ADDENDUM #4

PROJECT: Cerise Park Waterline Bore Project
BID NO: 21-018
FROM: Scott Murphy
DATE: June 24, 2021

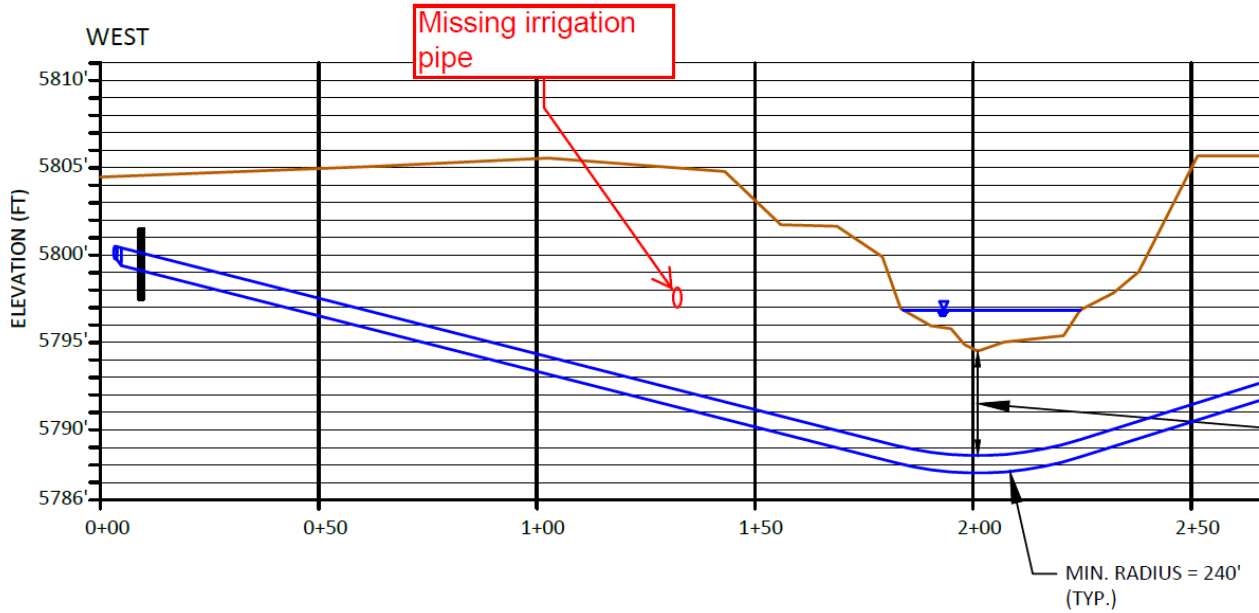
1. A 12" diameter irrigation line is present in the bore profile that was missed in the initial survey. This is shown in an excerpt of the profile drawing below:
